TO: HEARINGS OFFICER

FROM: LISA ANDERSON-OGILVIE, AICP, DEPUTY COMMUNITY DEVELOPMENT
DIRECTOR AND PLANNING ADMINISTRATOR

SUBJECT: **CONDITIONAL USE / PARTITION TENTATIVE PLAN / CLASS 3 SITE PLAN
REVIEW / CLASS 2 ADJUSTMENT CASE NO. CU-PAR-SPR-ADJ25-03
3271 LANCASTER DRIVE NE – 97305
AMANDA NO. 24-124417-PLN**

Summary: Development of a new drive-through oil change business.

① TENTATIVE PARTITION PLAN
1" = 20'-0"

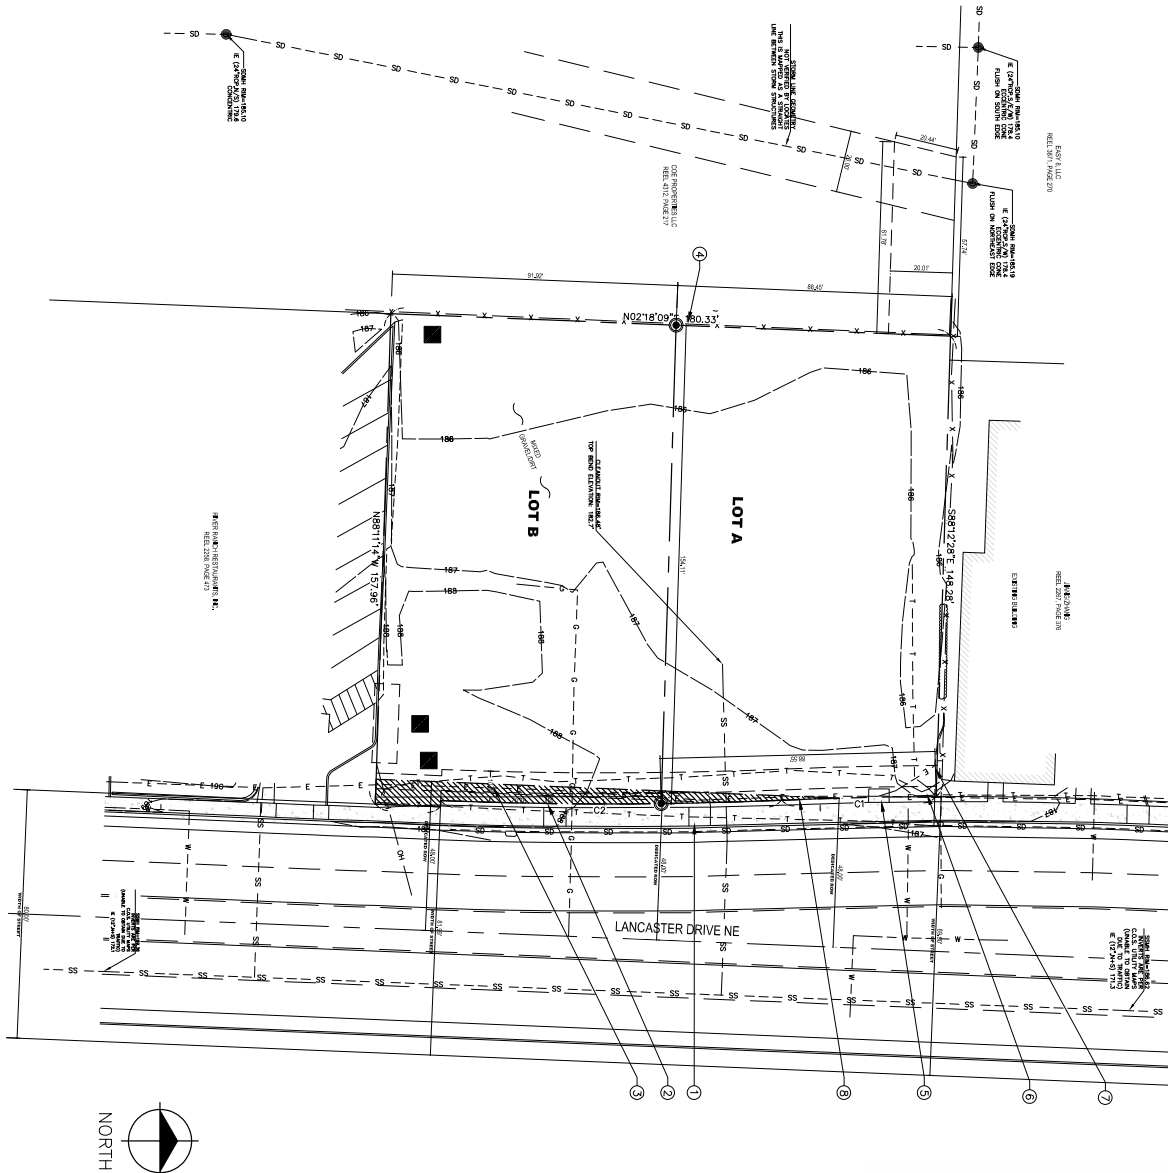
Finding: As shown on the tentative partition plan (**Attachment B**), proposed Parcel 1 approximately 0.31-acres (13,359 square feet) and approximately 89 feet in width and 150 feet in depth, with 88 feet of frontage along Lancaster Drive NE. Proposed Parcel 2 is approximately 0.33-acres (14,331 square feet) and approximately 91 feet in width and 156 feet in depth, with 92 feet of frontage along Lancaster Drive NE. The proposed parcels meet the minimum size and street frontage requirements of the CR zone and are of sufficient size and dimension to permit future development of uses allowed within the zone. These standards are met.

SRC 804.035(a) provides that driveway approaches onto arterial streets are permitted where they provide shared access between two or more abutting properties. The applicant's tentative partition plan indicates that the existing driveway approach to Lancaster Drive NE will be shared between proposed Parcels 1 and 2. Prior to final plat approval, the applicant shall provide a shared access easement between Parcels 1 and 2 for the driveway approach to Lancaster Drive NE.

Condition 8: On the final plat, provide a shared access easement between Parcels 1 and 2 for the driveway approach to Lancaster Drive NE.

① OVERALL SITE PLAN
1" = 10'-0"

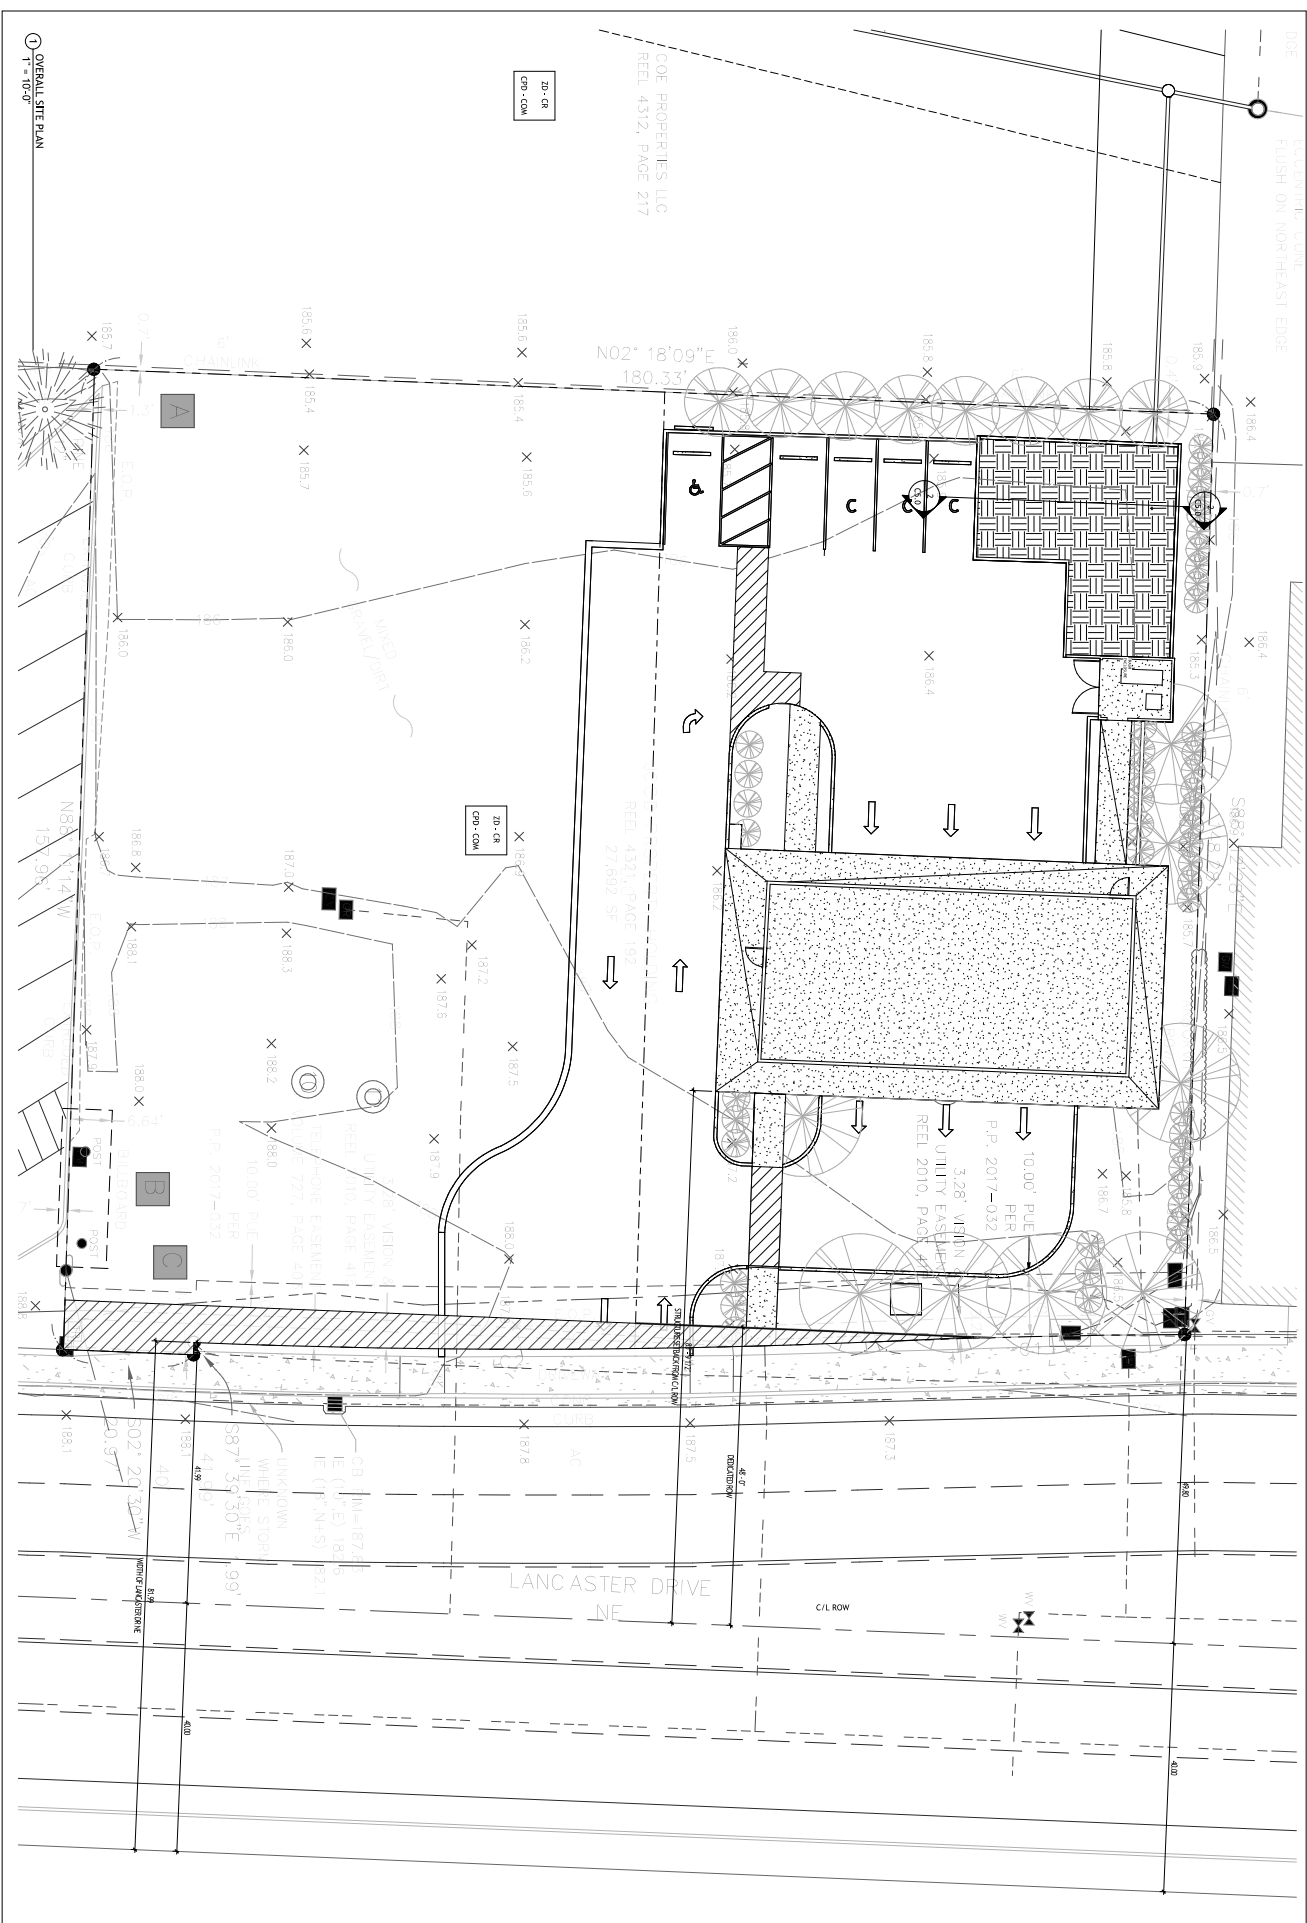
Finding: The development plans indicate an enclosure opening width of nine feet with gates that will be able to swing 90 degrees. As previously addressed, the applicant has requested an adjustment to the minimum gate opening, addressed in Section 9 of this report.

Finding: All proposed pedestrian connections are at least five feet in width; however, the development plans indicate the connections will only be striped. To ensure the connections meet the standards of this section, the following condition shall apply.

Finding: The applicant's site plan shows a stormwater discharge for the proposed Green Stormwater Infrastructure (GSI) facility crossing over neighboring property to the west and draining to a public stormwater main that is located on private property. Prior to building permit issuance, the applicant shall obtain a private storm drain easement on abutting property to the west to connect the proposed GSI to a public stormwater main located on private property.

Condition 9: At time of building permit submittal, revise plans to provide pedestrian connections meeting the materials standards of SRC 800.065(b)(1)(B).

- Condition 11:** Prior to building permit issuance, the applicant shall obtain a private storm drain easement on abutting property to the west to connect the proposed Green Stormwater Infrastructure to a public stormwater main located on private property.
